Subject: ITB #1516-B: Broom Boulevard Culvert Replacement – Addendum 1

BROOM BLVD CULVERT REPLACEMENT

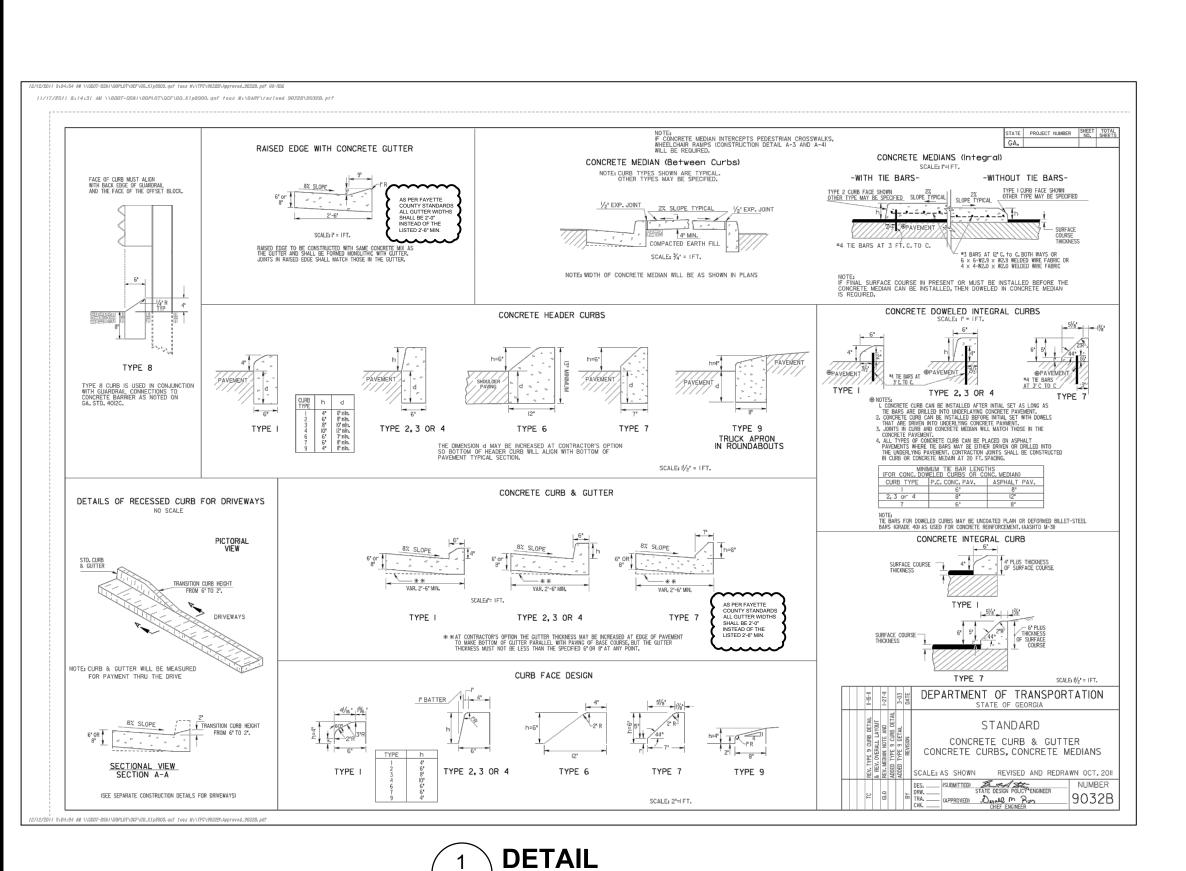
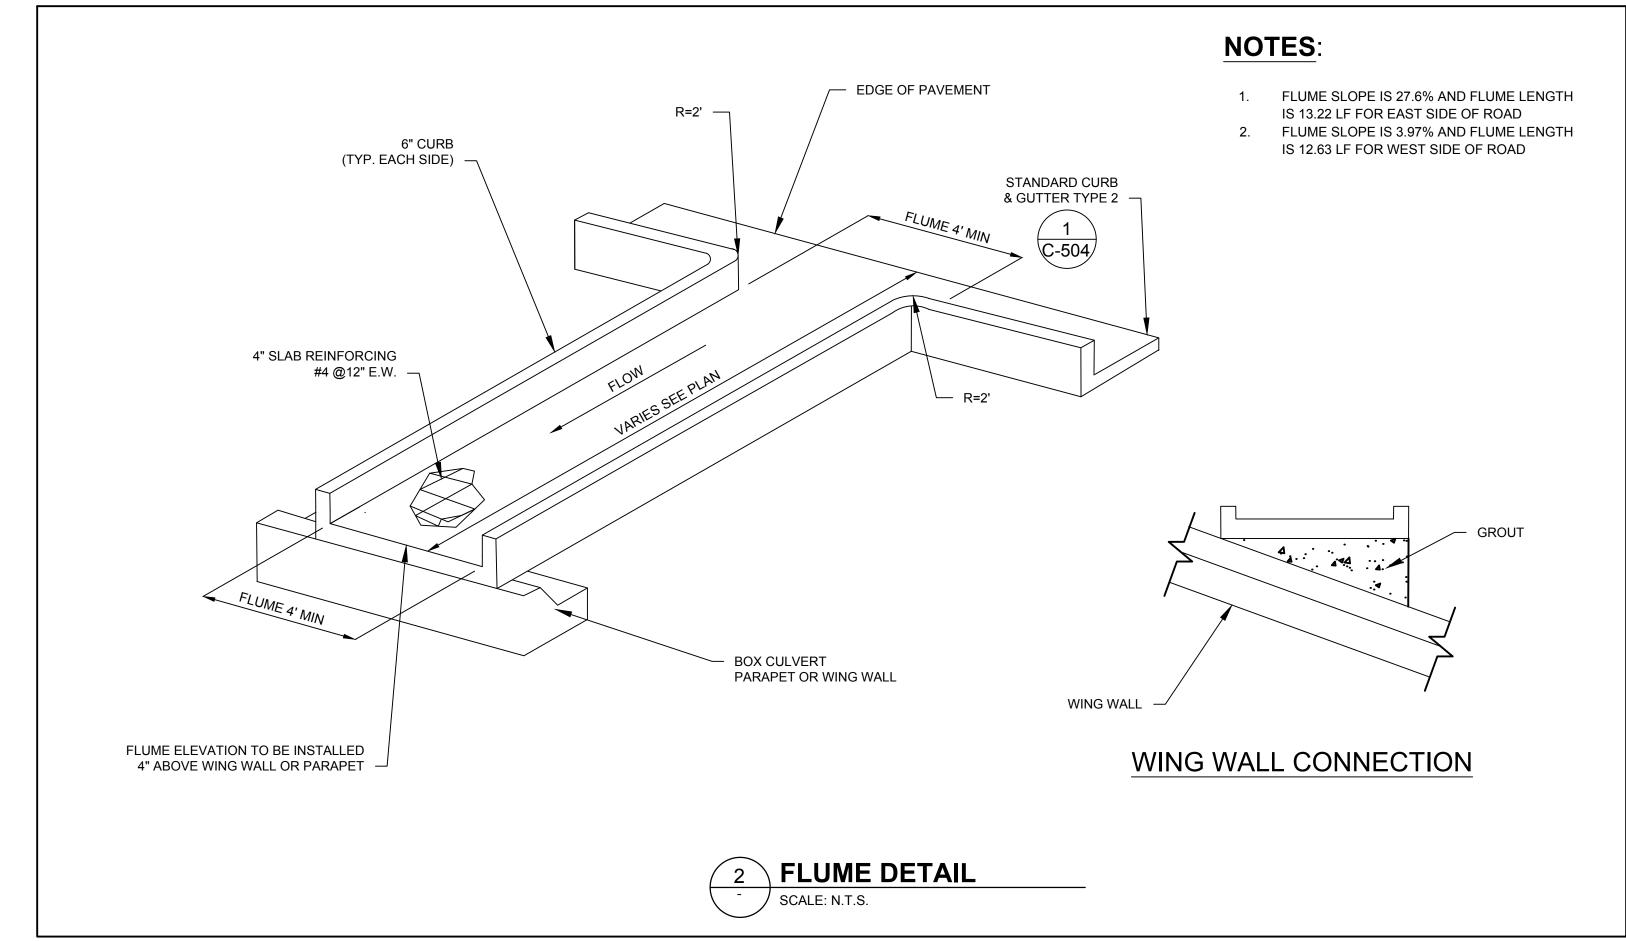
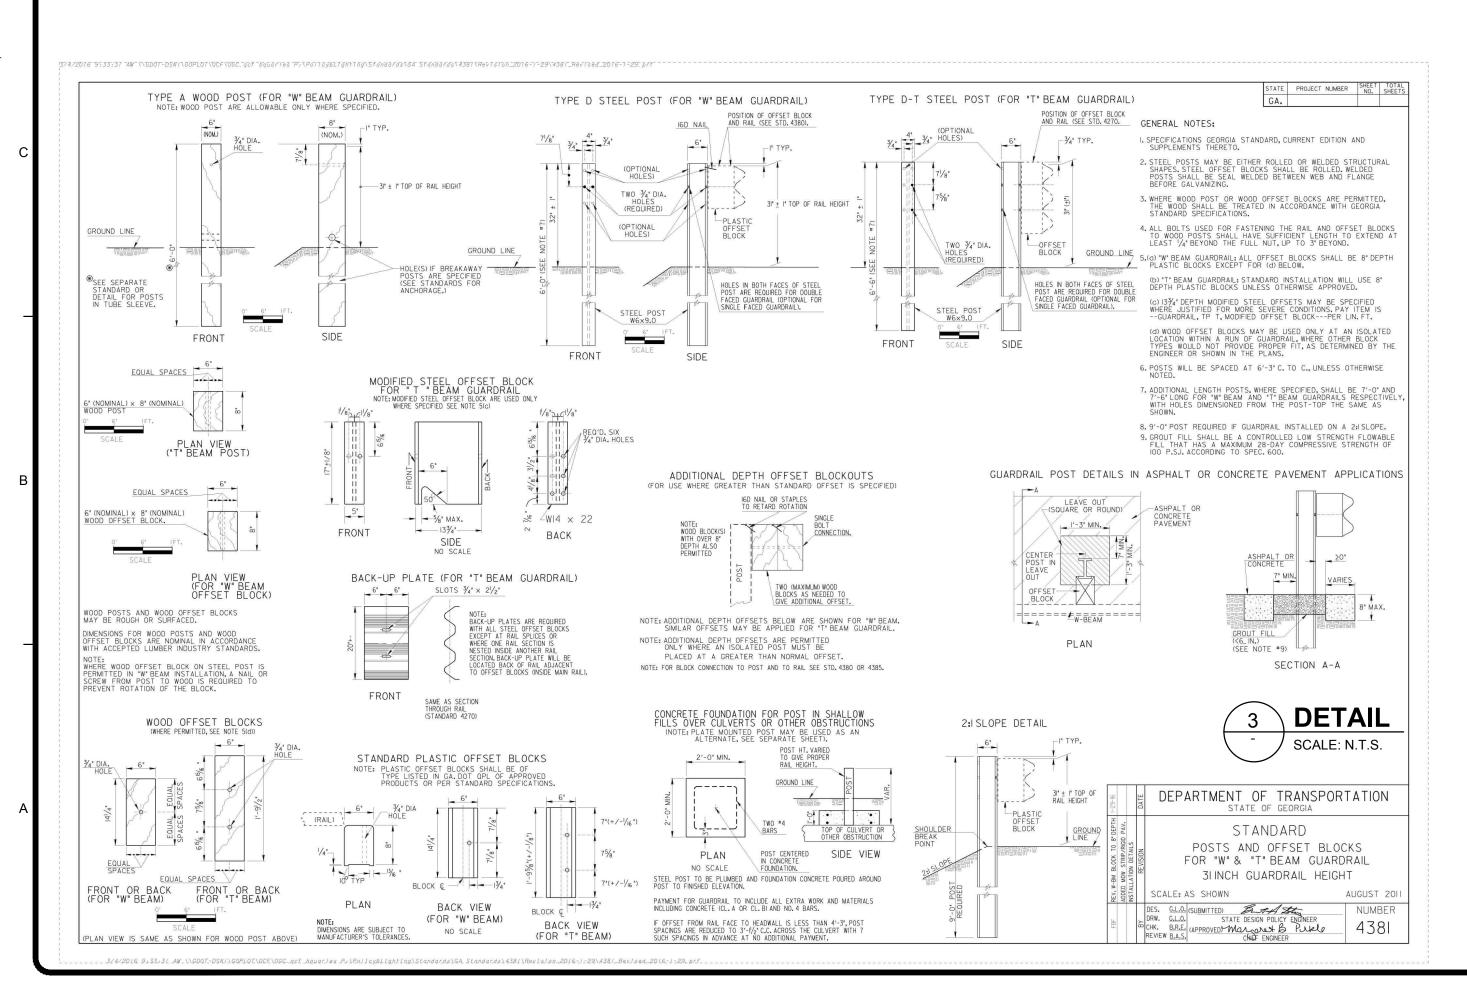
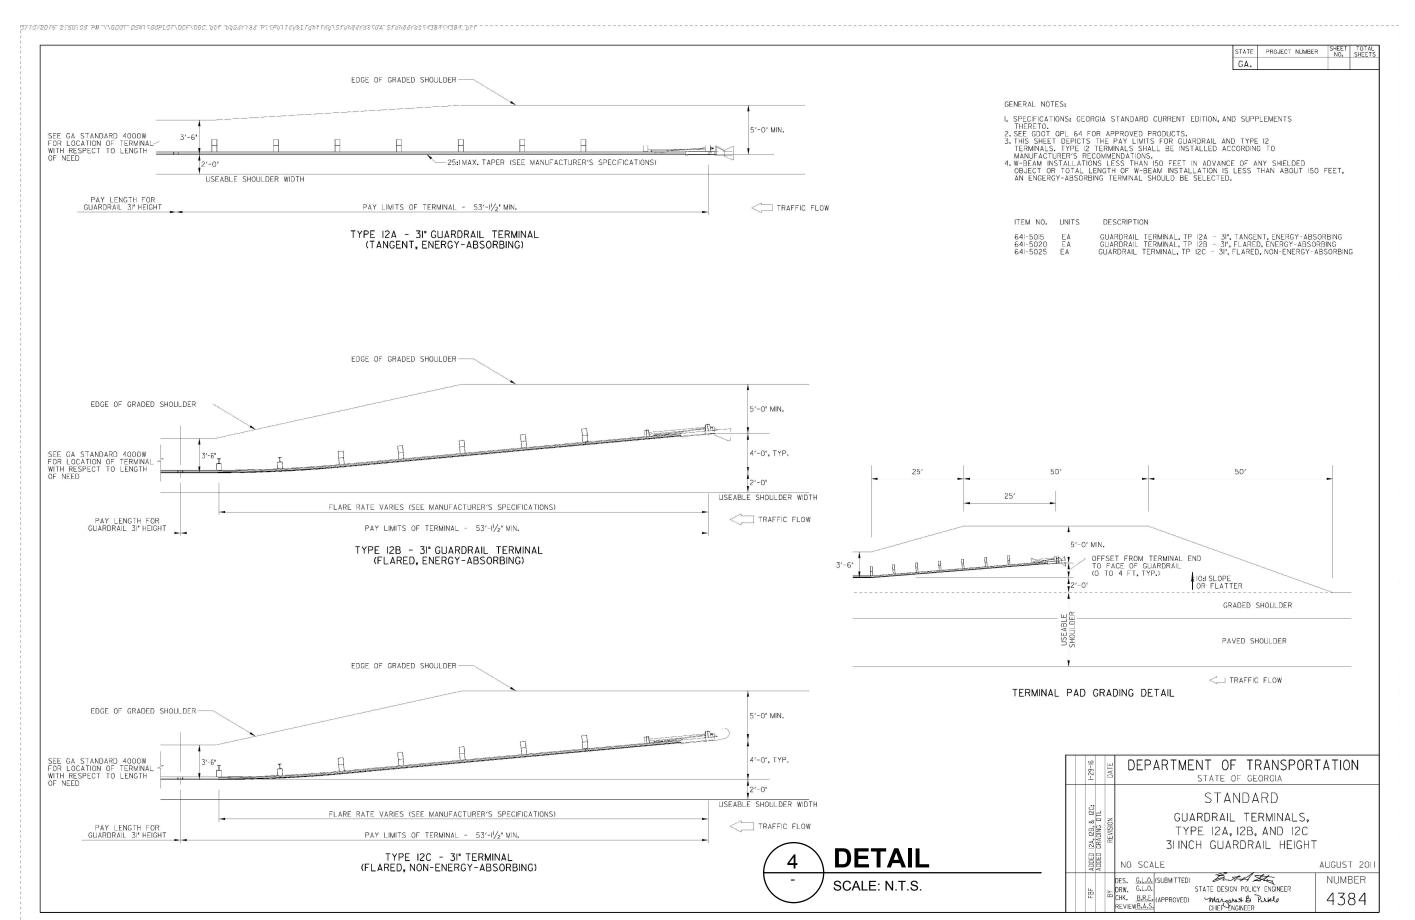
b. Can you address the issue of having breakaway rail over the culvert area?

Detail 3 on sheet C-504, GDOT 4383 has been replaced with GDOT 4381. This detail specifies steel posts instead of timber breakaway posts.
